CONSTRUCTION SUMMARY

KINGSMEN (THAMES) INC. / Havelock Corners (Kingsmen)

Lot/Unit: 101 Phase/Building: 4A Model/Floor Plan: Robert (3604) Elev C 4 Bed - 2+1 Bath

Schedule B-1 1 of 3

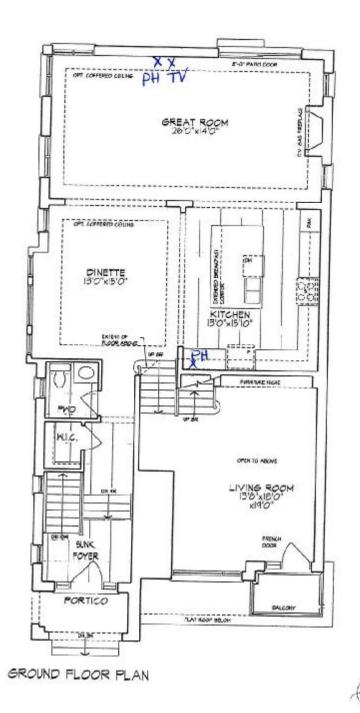
Inv. 4566	1 - To supply & install the standard Phone rough in the great room, kitchen and master	
	bedroom see sketch # 1 & # 2	
Line 58177	Note:	
18Mar20 / 18Mar20		
Countertop		
Inv. 4566	1 - As per scheduele "PE": Vendor to include level 1, 20cm granite or quartz in the kitchen, as	
	per plan, in lieu of the included lamnate counter tops. Selections to be made from builders standard samples.	
Line 58172	Note:	
18Mar20 / 18Mar20		
Electrical		
Inv. 4566	1 - To supply & install the standard T.V. rough in in the great room and master bedroom see sketch # 1 & # 2	
Line 58176	Note:	
18Mar20 / 18Mar20		
Hardwood		
Inv. 4566	1 - As per scheduele "PE": Vendor to include engineered hardwood throughout the 2nd floor in lieu of included carpet, as per plan, and selections as outlined in schedule A. This has no cash value.	
Line 58173	Note:	
18Mar20 / 18Mar20		
	l Air Conditioning	
Inv.4566	1 - As per scheduele "PE": Vendor to install capped gas line (rough in only) at rear of home

IIIV.4300	for future BBQ location. Location to be finalized at Vendors sole discretion.	
Line 58169	Note:	
101420 / 1024 - 20		
18Mar20 / 18Mar20		
18Mar20 / 18Mar20 Inv. 4566	1 - As per scheduele "PE": Vendor to install gas line (roung in only) to kitchen in at stove	
Inv. 4566	1 - As per scheduele "PE": Vendor to install gas line (roung in only) to kitchen in at stove location (as per plan) to include 110V code requirement Note:	
Inv.4566 Line 58170	location (as per plan) to include 110V code requirement	
Inv. 4566 Line 58170 18Mar20 / 18Mar20	location (as per plan) to include 110V code requirement Note:	
Inv.4566 Line 58170	location (as per plan) to include 110V code requirement	
Inv. 4566 Line 58170 18Mar20 / 18Mar20	location (as per plan) to include 110V code requirement Note: 1 - As per scheduele "PE": Vendor to supply & install air conditioning unit, sized accordingly,	
Inv.4566 Line 58170 18Mar20 / 18Mar20 Inv.4566	location (as per plan) to include 110V code requirement Note: 1 - As per scheduele "PE": Vendor to supply & install air conditioning unit, sized accordingly, from vendors standard samples.
